**NEW YORK STATE THRUWAY AUTHORITY  
DEPARTMENT OF ENGINEERING**

**AMENDMENT NO. 3  
TO**

**CONTRACT TAS 24-20B  
D214978  
REPLACEMENT OF THE I-90 BRIDGE OVER  
ORISKANY BOULEVARD (NY 69) AT MILEPOST 238.22  
IN THE SYRACUSE DIVISION  
OF THE NEW YORK STATE THRUWAY  
IN ONEIDA COUNTY**

TITLE OF PROJECT REPLACEMENT OF I-90 BRIDGE OVER ORISKANY BOULEVARD	CONTRACT NUMBER: TAS 24-20B
LOCATION OF PROJECT SYRACUSE DIVISION MP 238.22	DATE: 04/03/2024
TITLE OF DRAWING CONCRETE BARRIER PLAN AND DETAILS (SHEET 2 OF 2)	DRAWING NUMBER: ST-51

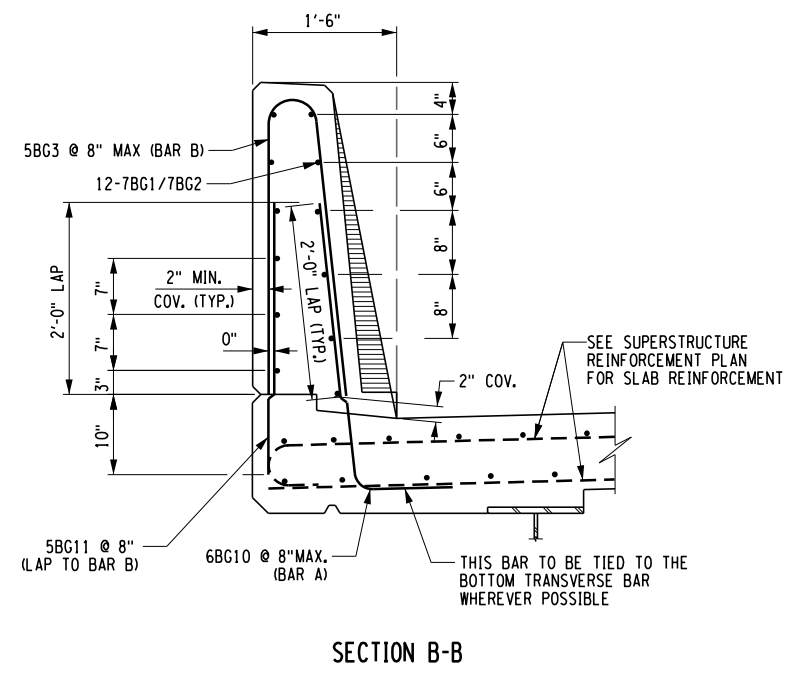
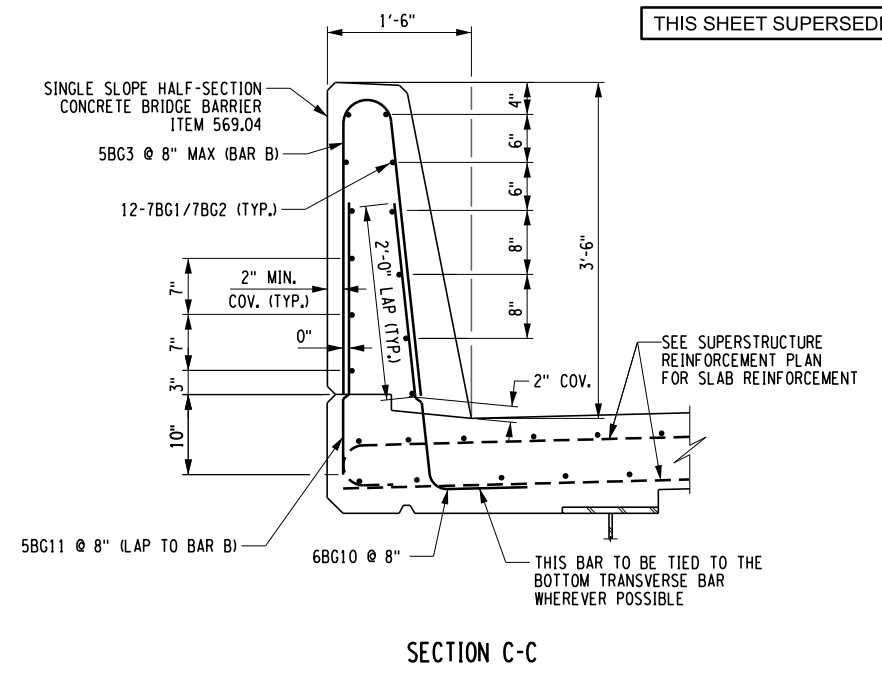
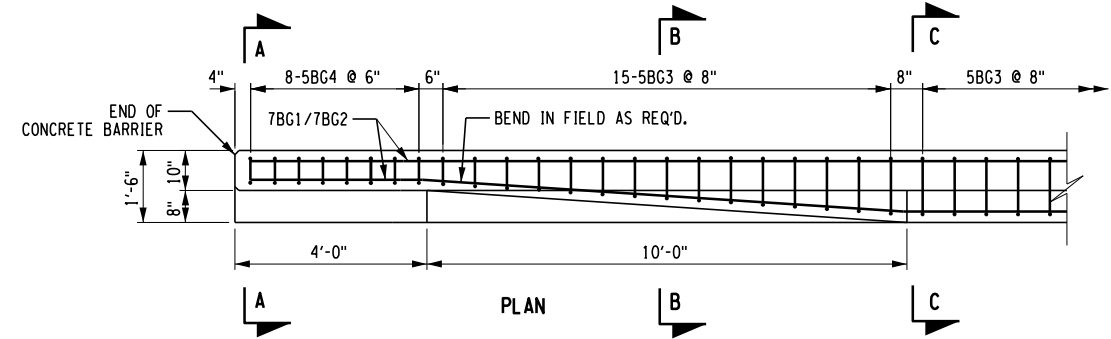
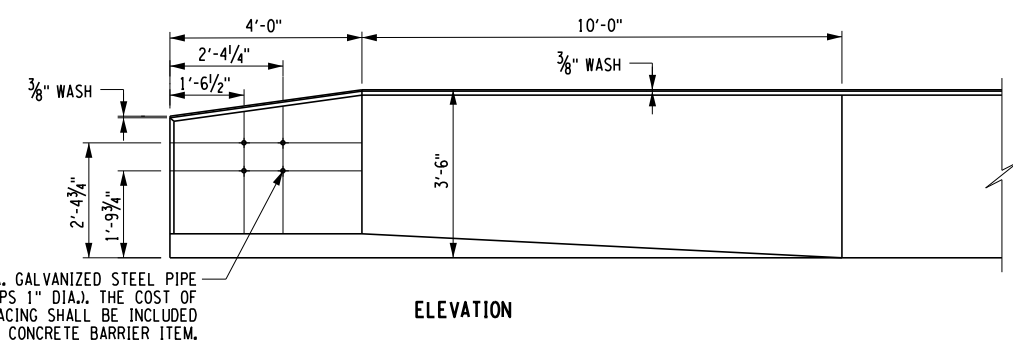
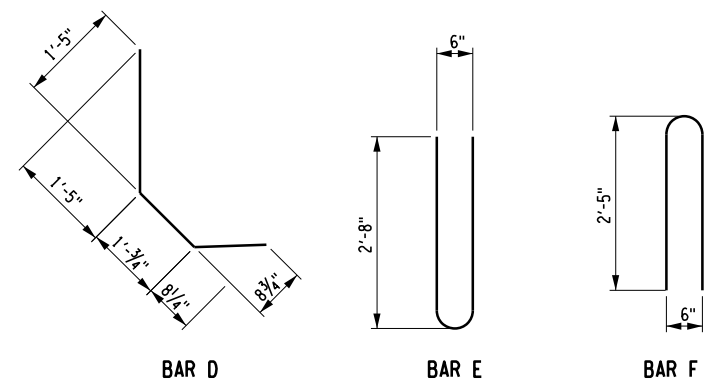
2. **DELETE** Drawing Number ST-51, Sheet 110 of 120, and **SUBSTITUTE** with the attached Drawing Number ST-51, Sheet 110-A3. Note 5 was revised to clarify payment of the reinforcement.
3. **DELETE** Drawing Numbers ST-60 and ST-61, Sheets 119 and 120 of 120, and **SUBSTITUTE** with the attached Drawing Numbers ST-60 and ST-61, Sheets 119-A3 and 120-A3, respectively. The Bar Lists were revised to include the appropriate item number for payment.

- FOR DECK REINFORCEMENT AND ADDITIONAL OVERHANG REINFORCEMENT DETAILS. SEE DWGS. ST-44, ST-45, & ST-50.
- FOR ADDITIONAL INFORMATION REGARDING THE DOWELS EXTENDING INTO THE CONCRETE BRIDGE BARRIER FROM THE SUPERSTRUCTURE SLAB, SEE BARRIER DETAIL ON DWG. ST-50.
- FOR SINGLE SLOPE (HALF-SECTION) CONCRETE BRIDGE BARRIER REINFORCEMENT BAR LIST, SEE DWG. ST-60.
- FOR DETAILS OF THE PROTECTIVE SCREEN SNOW FENCE TO BE MOUNTED TO THE OUTSIDE FENCE OF THE CONCRETE BRIDGE BARRIER, SEE DWG. ST-52.
- BAR REINFORCEMENT SHALL MEET THE REQUIREMENTS OF STANDARD SPECIFICATION SECTION 556 FOR GALVANIZED REINFORCEMENT. COST OF BARRIER REINFORCEMENT, INCLUDING DOWELS THAT ARE PLACED IN THE SUPERSTRUCTURE SLAB, IS INCLUDED IN THE COST OF ITEM 569.04.
